RESPONSE TO INFORMATION REQUEST - DEVELOPMENT PERMIT FOR A COMBINED APPLICATION (CODE ASSESSMENT) RETIREMENT FACILITY - JOHNSTON ROAD, MOSSMAN GORGE - LOT 1 ON SP150474

COUNCIL REF: CA1235/2015

RESPONSE TO INFORMATION REQUEST FOR COMBINED APPLICATION (CODE ASSESSMENT) RETIREMENT FACILITY – JOHNSTON ROAD, MOSSMAN GORGE COUNCIL REF: CA 1235/2015 (765610)

Figure C1 Existing Case Preliminary Flood Level - 200 Year ARI

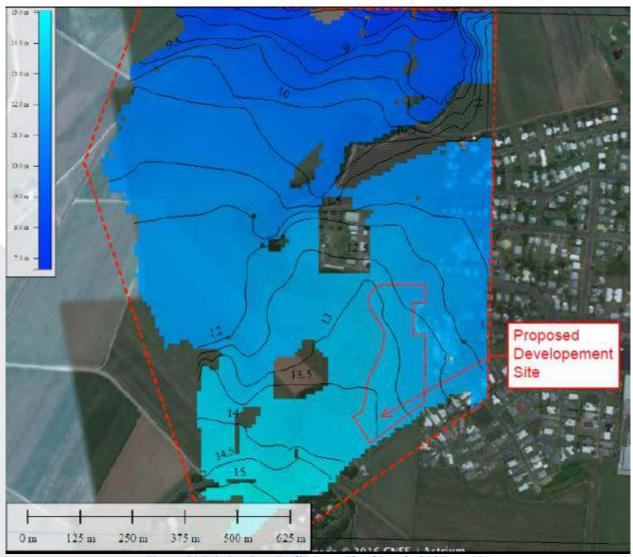
Item 3 - Clarify the extent of fill required to accommodate the proposed development.

A flood investigation of Marrs Creek has been conducted using 2D flood modelling software XPStorm. Results indicate the flood level for an ARI 200 year storm event in the vicinity of the proposed development are approximately 13.5m to 13.7m AHD (refer to the attached Figure C1). A floodwater height of 13.7m has been has been identified at the southernmost site boundary adjacent to Marrs Creek. In the center of the proposed building location a floodwater height of 13.5m has been identified.

Thomson and Set Mossman aged care plus centre Drawing Title SITE Plan Drawing Number 15.0285.11 SK02 Client The Salvation army Date 11.02.2016 Scale 1:1000 9

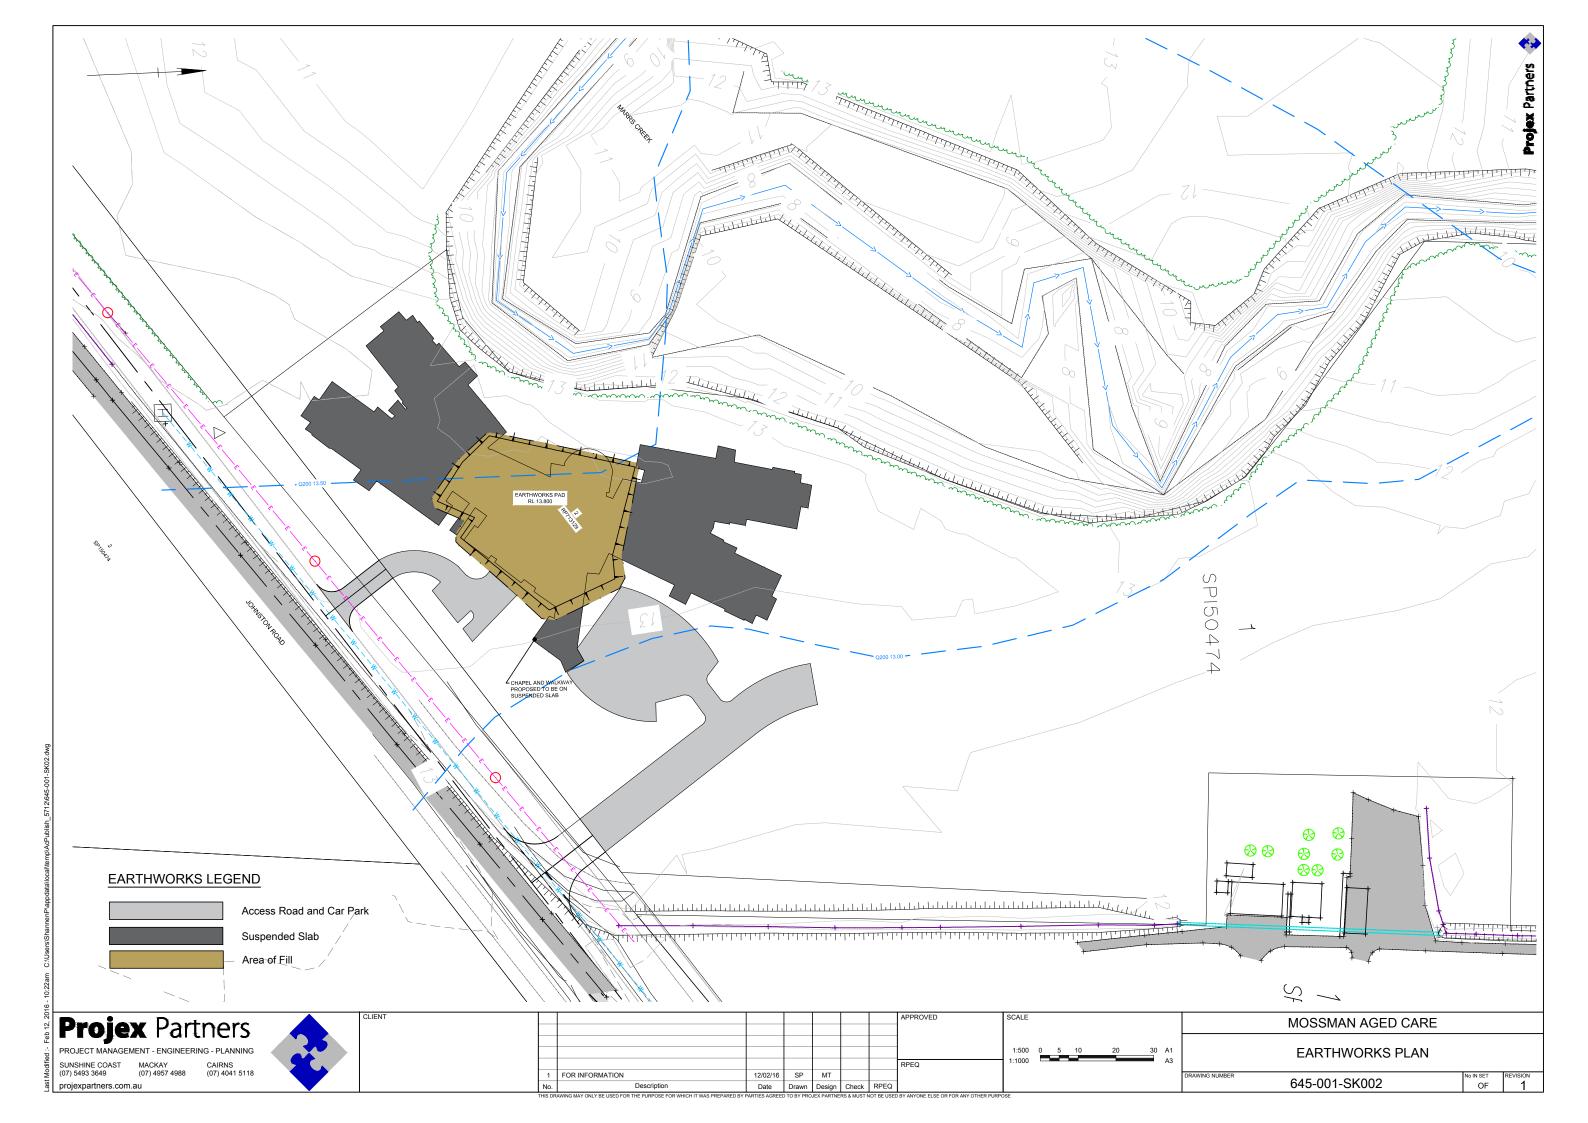
4. Provide design detail of the extent of works proposed for the access easement in Stage 1;

A site plan is provided at **Attachment D** that describes the concept for the proposed new road and site access off the proposed road.

Given that the overall design scheme incorporates a landscaped median and a 25 metre road reserve, the proposed road attributes are recommended as follows:

- 19.0 metre road reserve;
- 4.0 metre carriageway width;
- 4.5 metre verge minimum; however, noting that the proposed road reserve is 25 metres wide a
 7.5 metre verge is proposed; and
- 2.0 metre median (with the opportunity to increase during detailed design provided a minimum 4.5 metre verge is maintained).
